# Staff Summary Report

**SUBJECT:** Hold a public meeting for a Development Plan Review for COBBLESTONE COURT PHASE III located at 9020 South McClintock Drive.

**DOCUMENT NAME:** DRCr\_CobbleStoneCourtIII\_081407      **PLANNED DEVELOPMENT (0406)**

**DPR07138** – Development Plan Review including site plan, building elevations, and landscape plan.

Development of the View  
 JH  
 FLOOR PLAN  
 DR-3

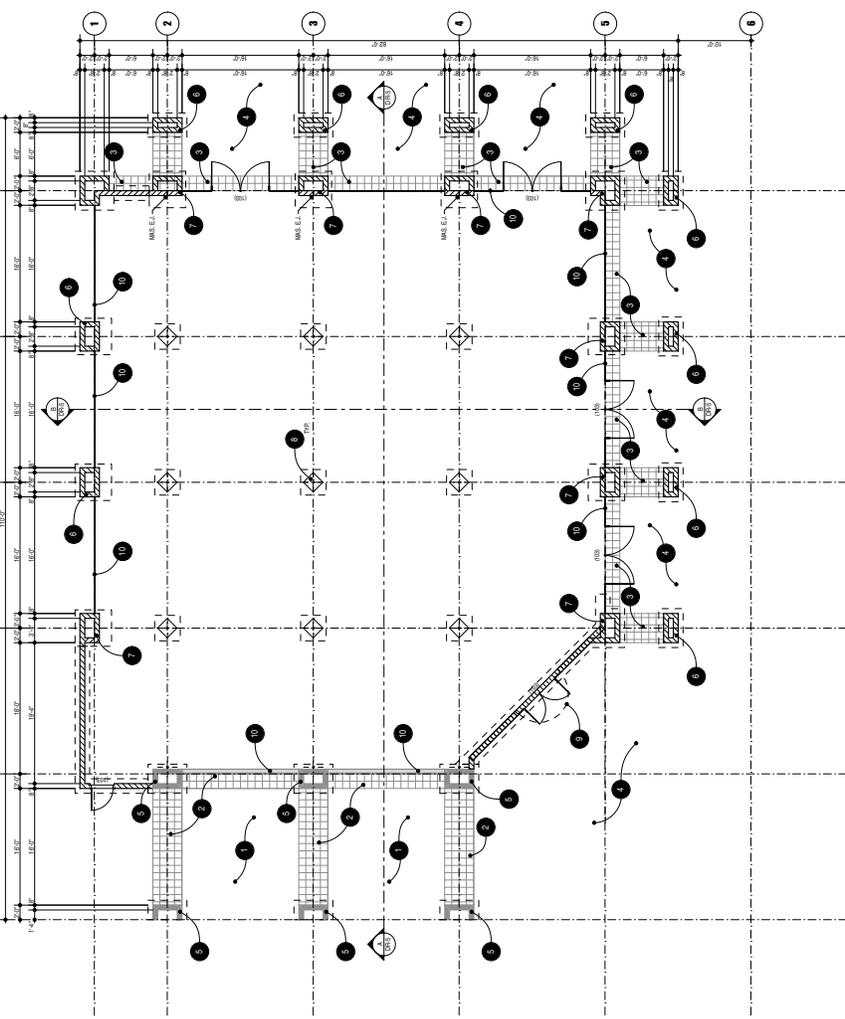
8. Public Restroom Security:
  - a. Lights in restrooms:
    - 1) Provide 50% night lights
    - 2) Activate by key or remote control mechanism
  - b. Single user restroom door hardware: provide a key bypass on the exterior side
- Provide vision panel at service and exit doors of the proposed building. Provide vision panel of high strength plastic or laminated glass, 3" wide, and of height that satisfies the requirement of the Americans with Disabilities Act (allow vertical slot window for viewing from a standing or sitting position). Where a vision panel is not desired, equip door with two 360 degree viewers (one for standing, one for sitting) and mount viewers in accordance with A.D.A. provisions. It is not necessary to retrofit doors on existing buildings.
